ASSEMBLY ORDINANCE 2026-33

UPDATE TO TITLE 23

BY DEVELOPMENT SERVICES DEPARTMENT

AO2026-33: UPDATES TO TITLE 23

23.10.104.15 Mobile food units.

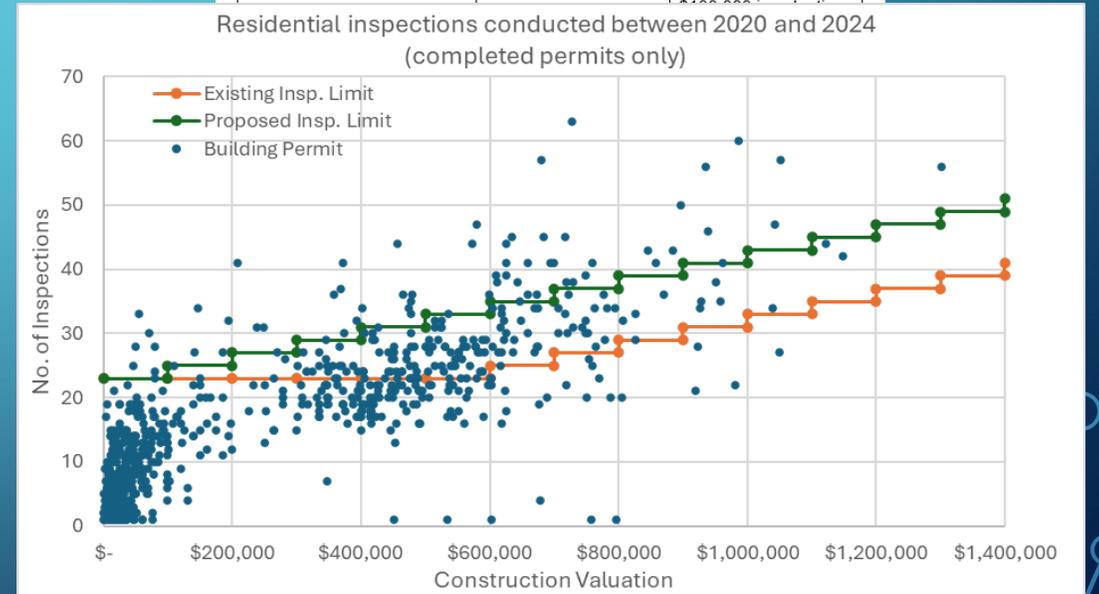
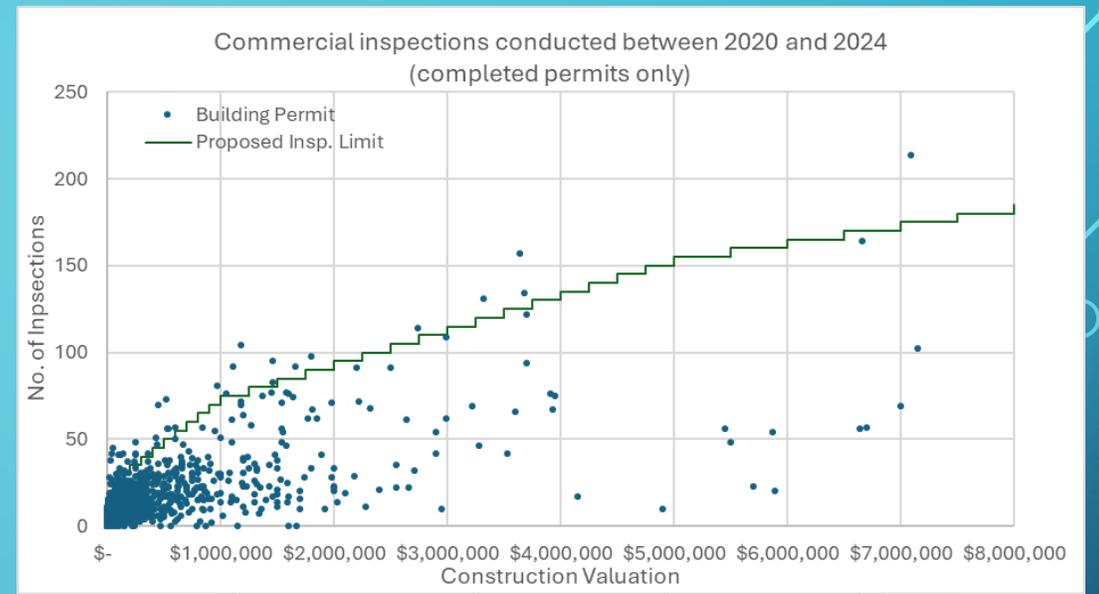
- 23.10.104.15 Mobile food units.
- 23.10.104.16 Shelter units located in allowed...

A. Mobile food units, including coffee carts and coffee huts, (hereafter within this section referred to as units) must obtain a building permit but are exempt from building plan review and building inspections except as required by this section under the following restrictions and requirements:

1. The unit shall not exceed 8 feet 6 inches in width, 48 feet in length or 15 feet in height, including overhangs.
2. The unit shall be readily moveable and one of the following:
 - a. Currently titled and licensed by the State of Alaska as a motor vehicle or a trailer having a tow hitch, chassis, axles, wheels and trailer lamps and reflectors in compliance with AMC chapter 9.44.
 - b. A pushcart as defined in AMC 16.60.050 and that satisfies the requirements of AMC 16.60.230F.
 - c. A factory built, readily moveable, intermodal shipping container repurposed to function as a mobile food unit which can be lifted or dragged onto a trailer or vehicle within one calendar day for transport.

SIGNIFICANT CHANGES - IBC

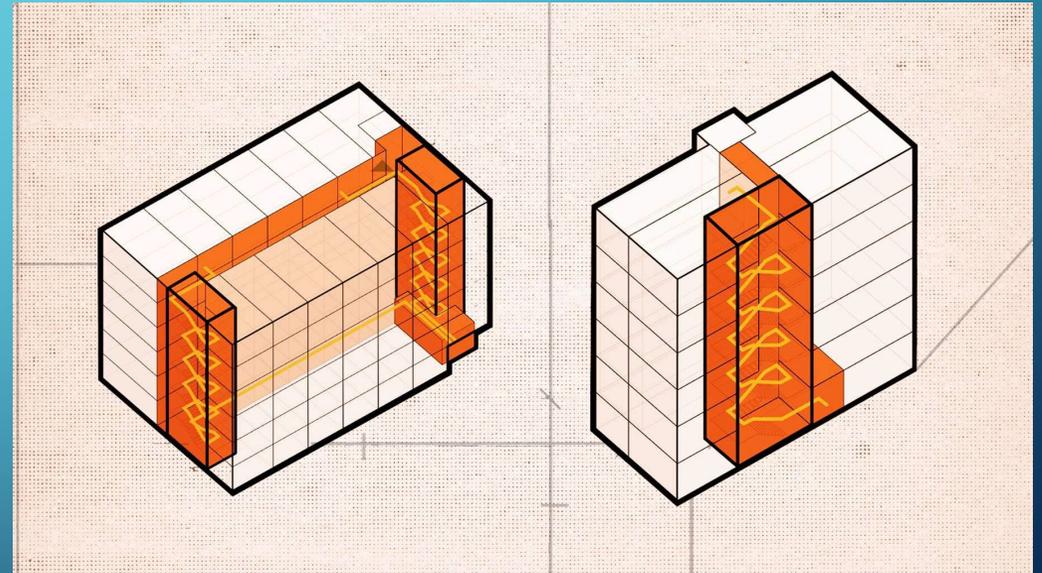
- 23.15.420.12 Single exit buildings...
 - Increases number of stories from 3 to 6.
 - Exception only sought within the BSSA due to the Insurance Services Office (ISO) class 1 fire department, plan review, and inspection requirements.
 - Currently seeking state approval through “Request for Modification” process, changes to be expected.

SIGNIFICANT CHANGES - UPC

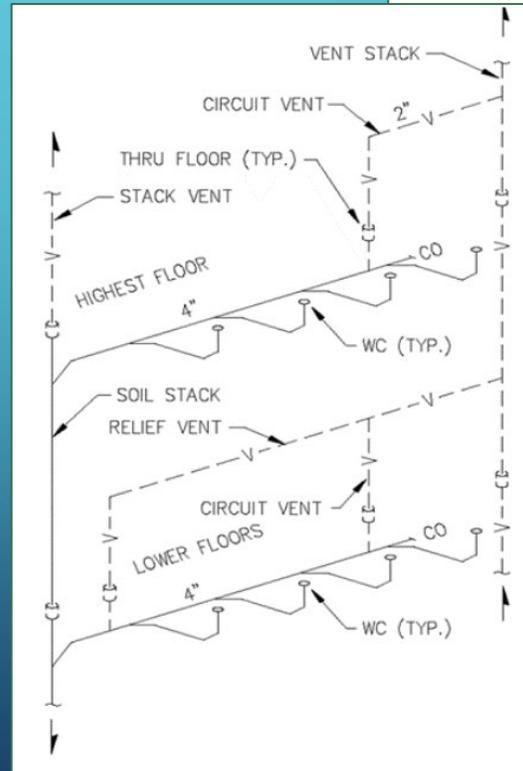
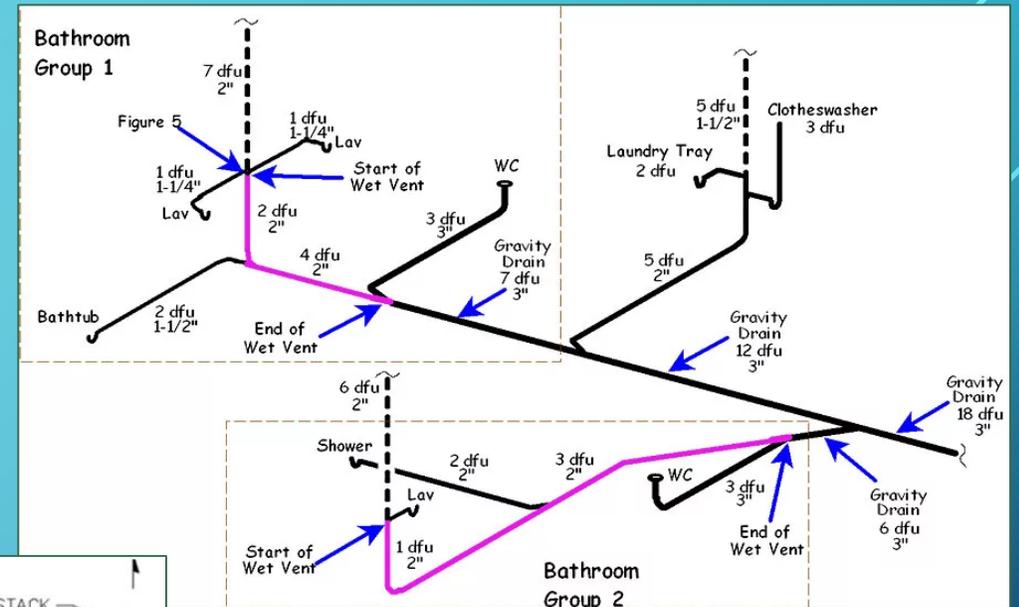
- 23.25.908.2 Horizontal wet venting for bathroom groups
 - Approvable in field
- 23.25.911.0 Circuit venting
 - Approvable with diagram and review
